**SUBDIVISION REVIEW SHEET****CASE NO.:** C8-2021-0050.0A**COMMISSION DATE:** July 18, 2023**SUBDIVISION NAME:** 607 Montopolis Drive Subdivision**ADDRESS:** 607 Montopolis Dr**APPLICANT:** Sean Murphy (L4S, LLC)**AGENT:** Grant Geissinger (Southwest Engineers, Inc.)**ZONING:** SF-3-NP (single family residence)**NEIGHBORHOOD PLAN:** Montopolis**AREA:** 0.939 acre (40,848 sf)**LOTS:** 5**COUNTY:** Travis**DISTRICT:** 3**WATERSHED:** Country Club East**JURISDICTION:** Full Purpose**SIDEWALKS:** Sidewalks will be constructed along Montopolis Dr and Thrasher Ln.**DEPARTMENT COMMENTS:**

**CITY OF AUSTIN –DEVELOPMENT SERVICES DEPARTMENT  
SUBDIVISION APPLICATION – MASTER COMMENT REPORT**

CASE NUMBER: C8-2021-0050.0A  
UPDATE: U2  
CASE MANAGER: Joey de la Garza      PHONE #: 512-974-2664

PROJECT NAME: 607 Montopolis Drive Subdivision  
LOCATION: 607 MONTOPOLIS DR

# 607 MONTOPOLIS

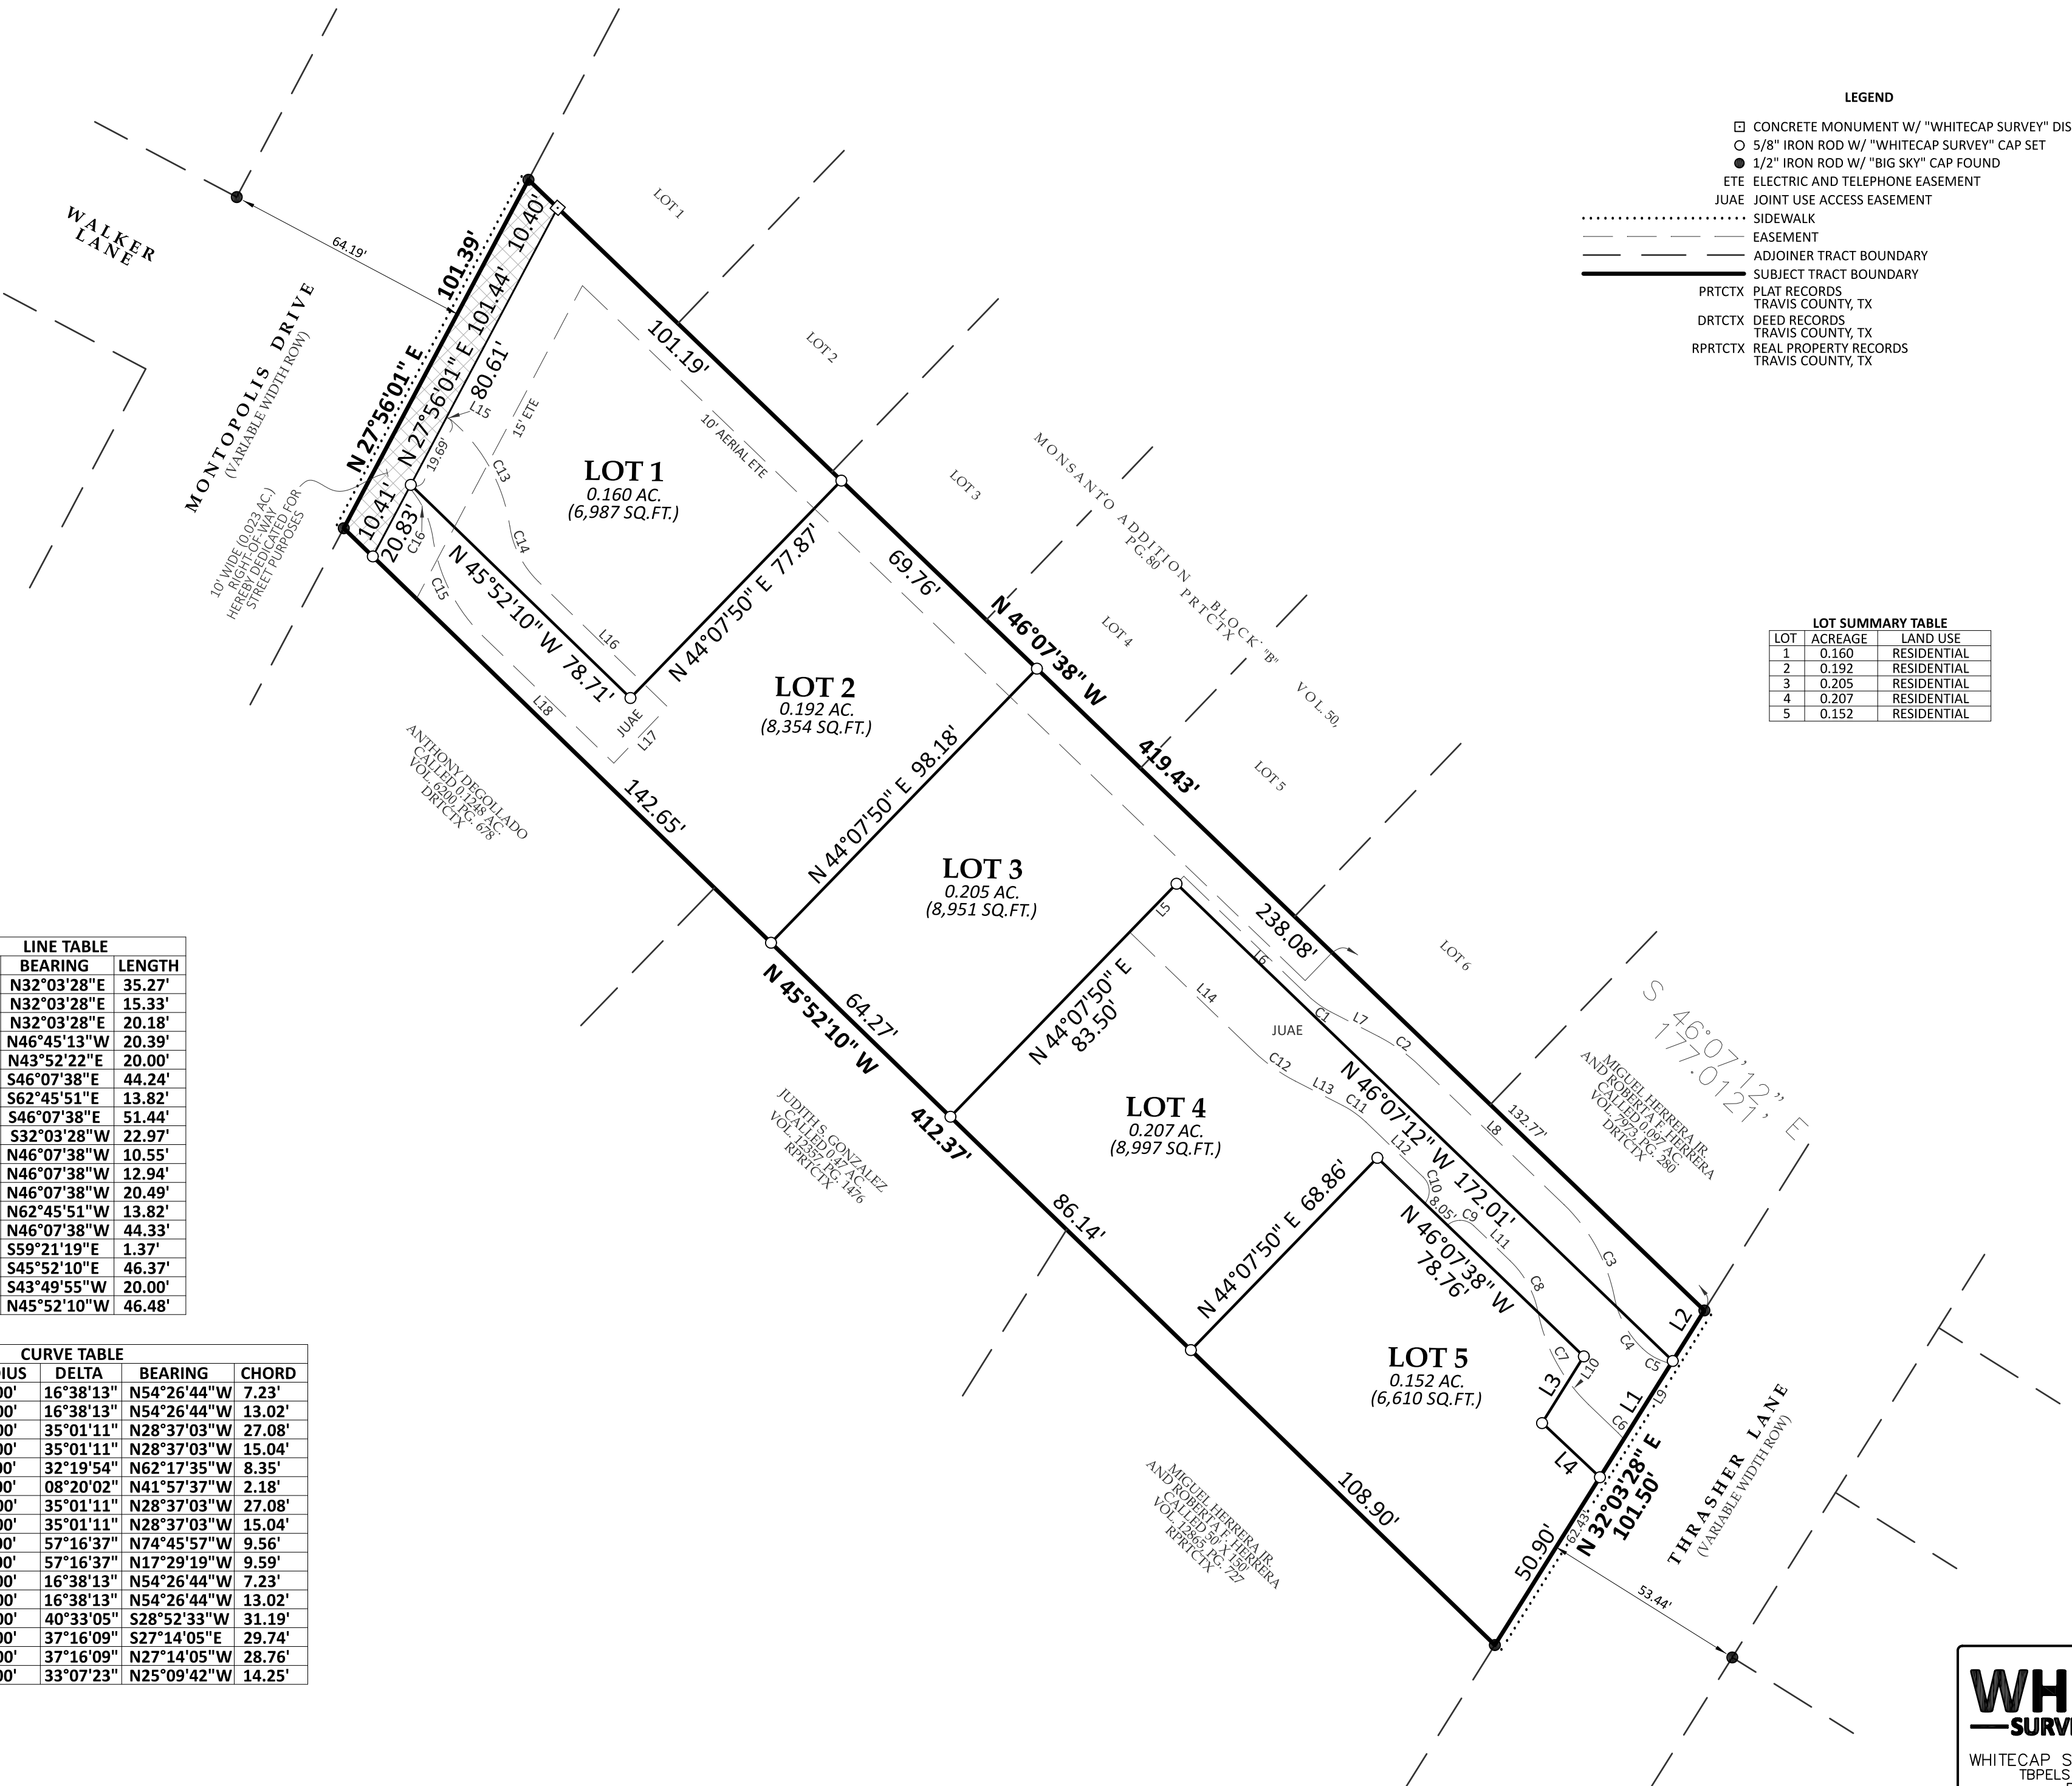
**Ten-foot electric distribution, electric telecommunications, and electric fiber easement is still required adjacent to Thrasher Ln ROW. Please show this easement on the face of the plat to clear this comment.**

**Thank you for the buildability exhibit that was requested for this original review comment. Please adjust the common lot line for the proposed Lot 1 & Lot 2 so that Lot 1 has a 50' distance from the 25' front setback on the south side of the lot. The diagram indicates a distance of 44.12'. Also, as a reminder, all fees associated with this application need to be paid prior to plat approval.**
